# ILC Interaction Region Configuration Change Request

LCWS14, Belgrade  
Karsten Buesser  
09.10.2014

<b>CHANGE REQUEST NO. ILC-CR-000N</b>	EDMS No: <b>D0000000xxxxxxx</b>	Created: <b>16-09-2014</b>
		Last modified: <b>24-09-2014</b>

## **DETECTOR HALL WITH VERTICAL SHAFT ACCESS**

# Outline of the Detector Hall (D/H) construction procedure - Hybrid A' Design -

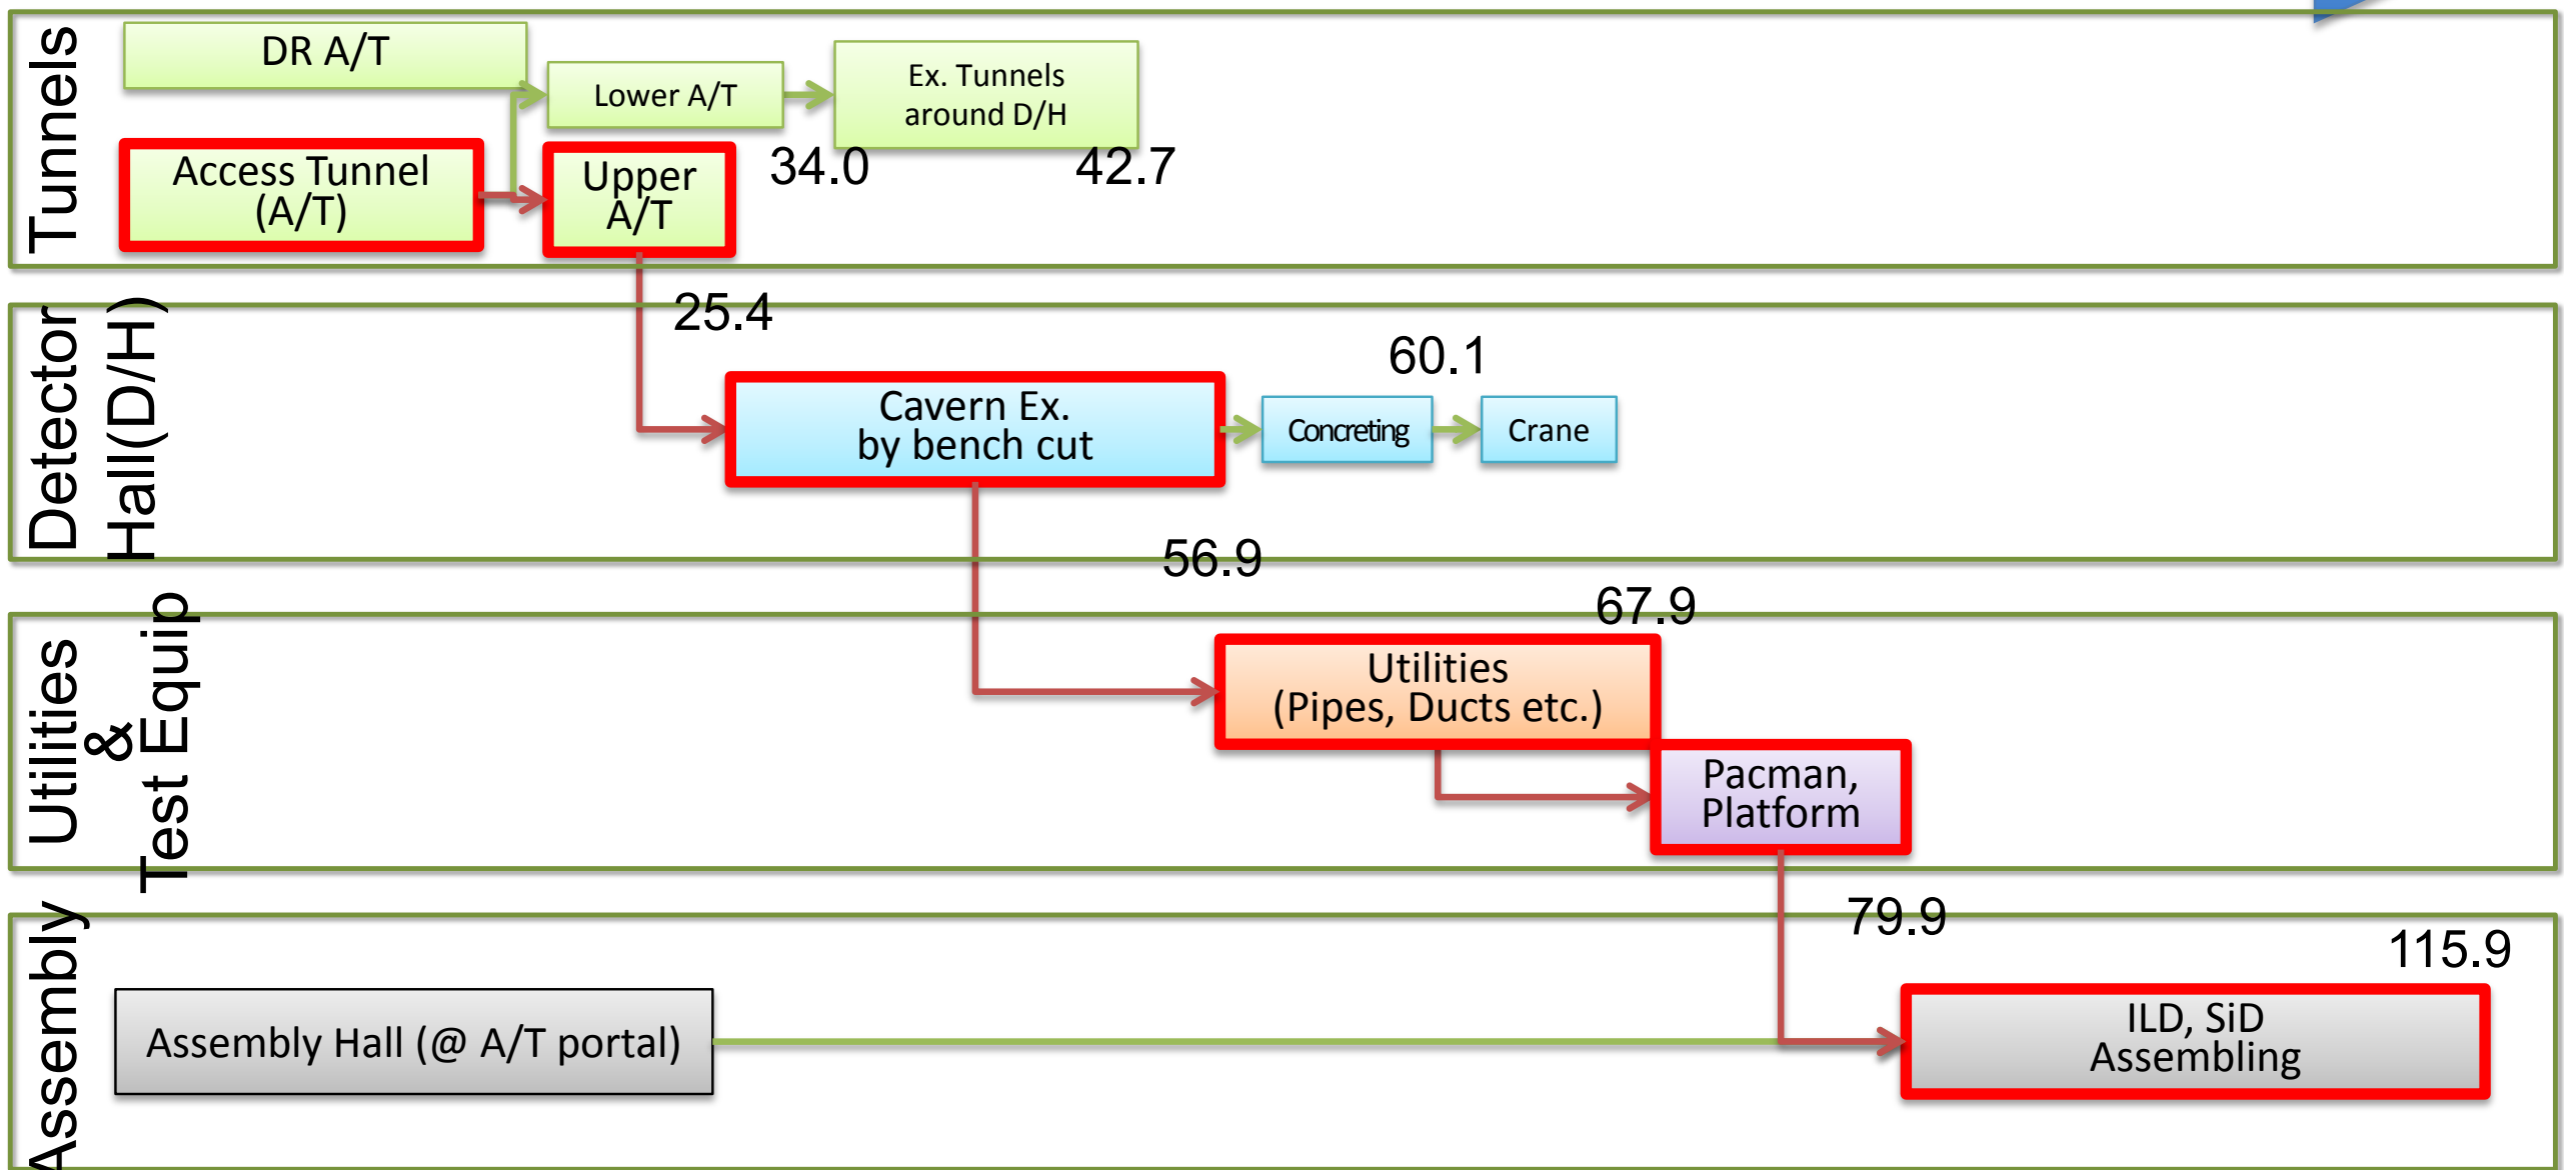
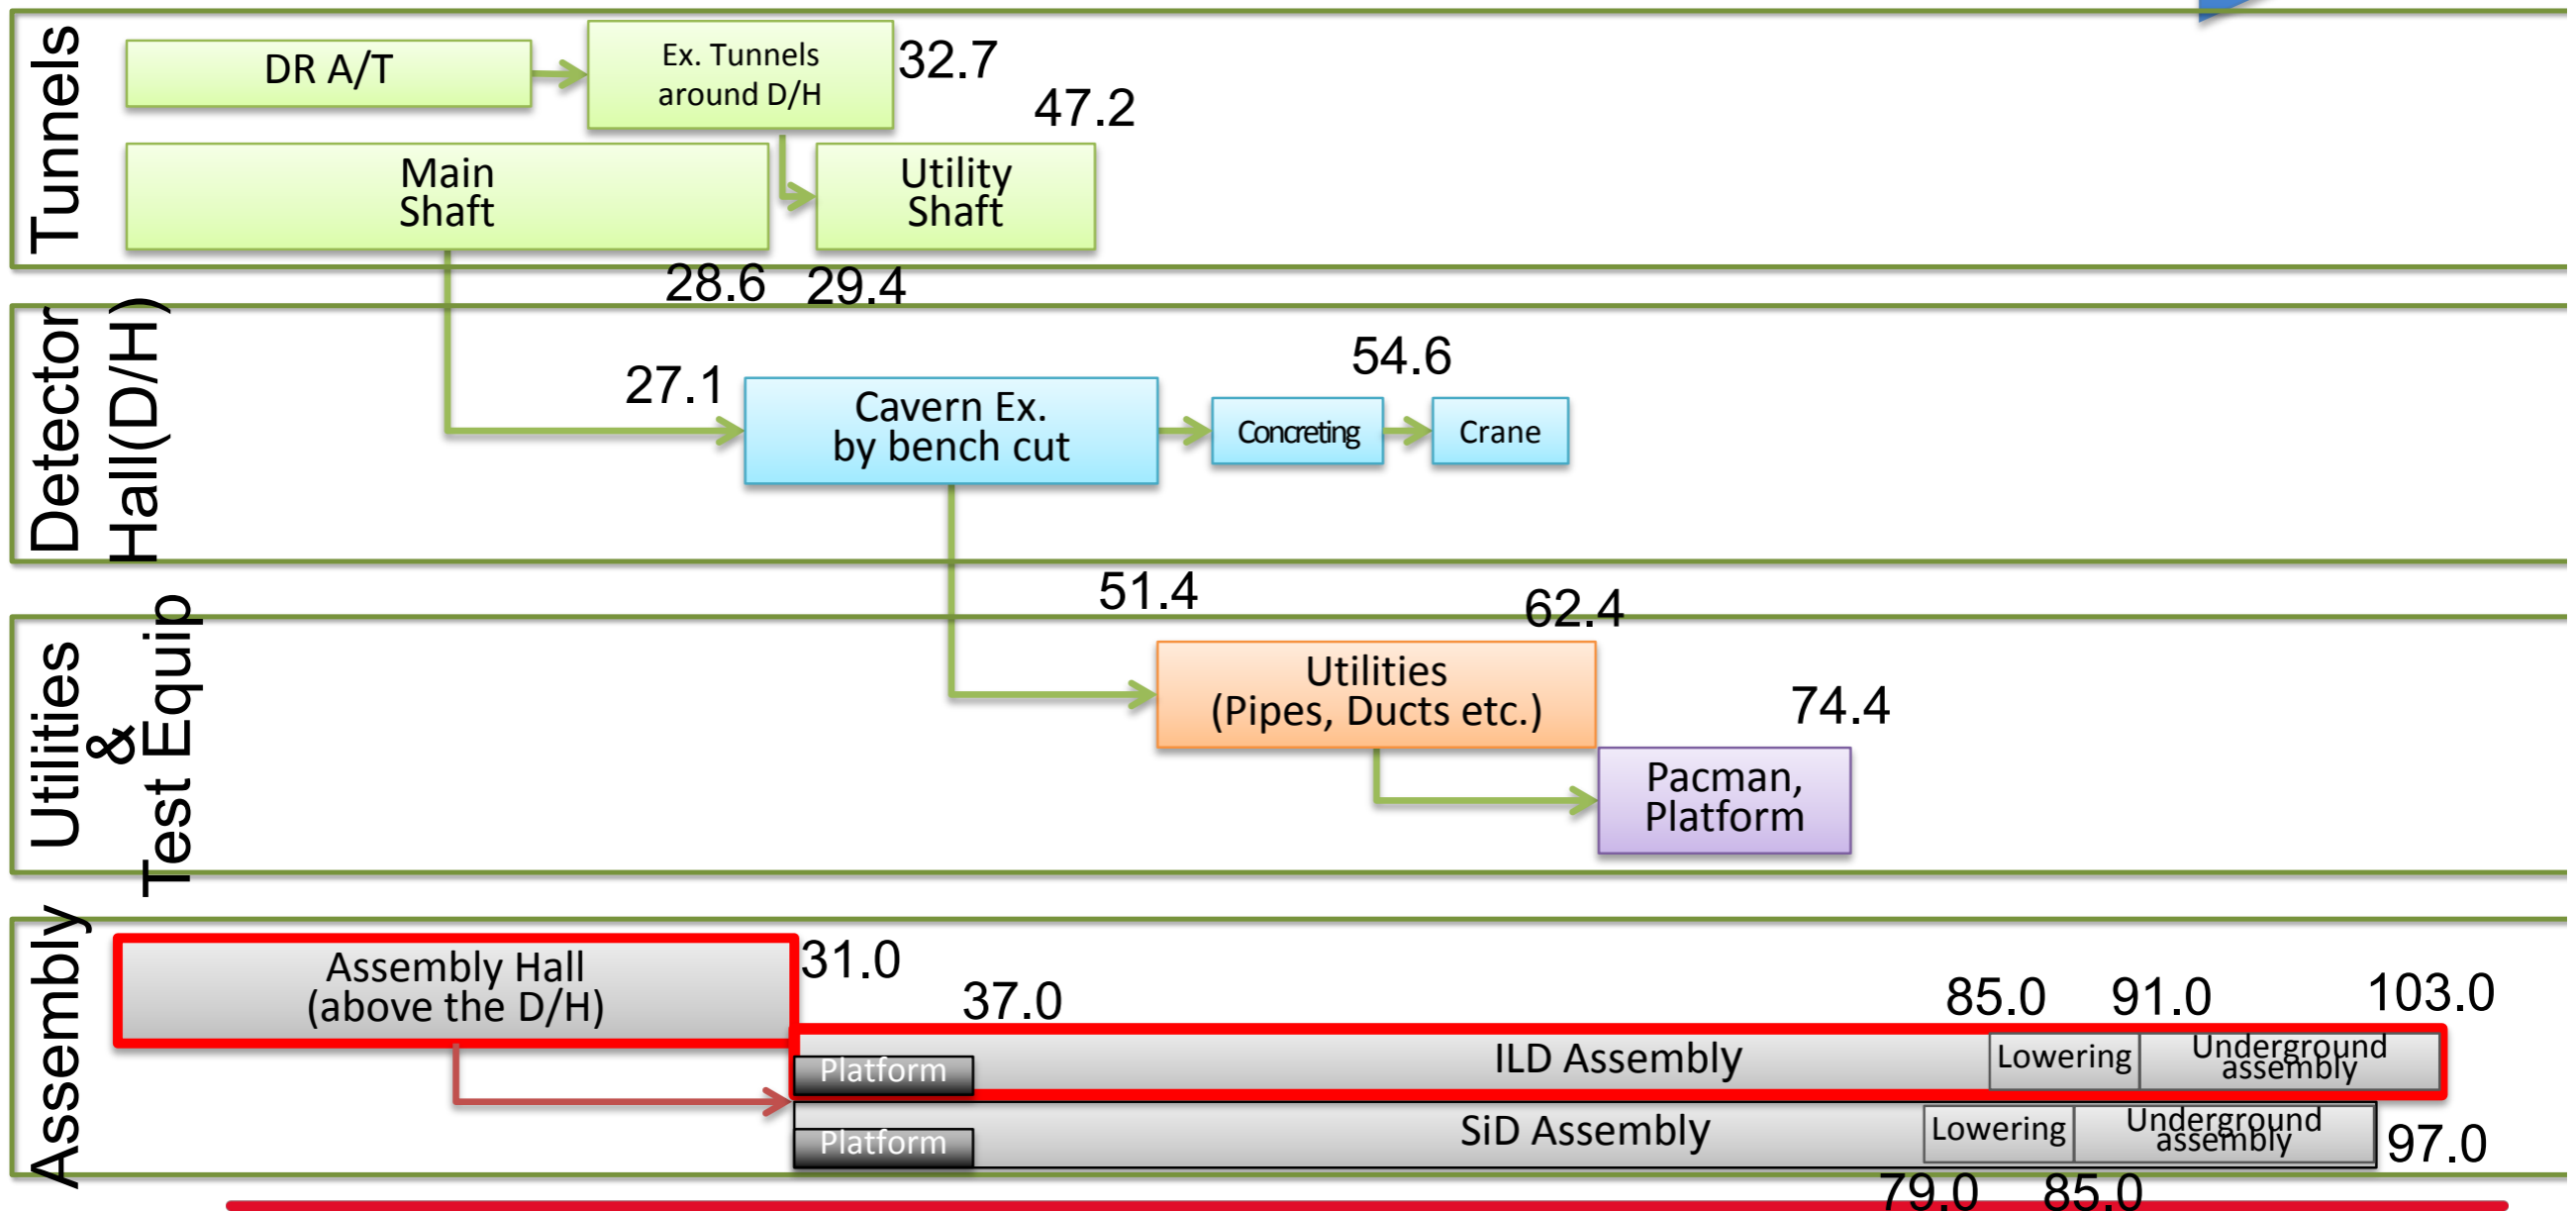
Time-line (const. period: 115.9 months)

Time-line (const. period: 103.0 months)
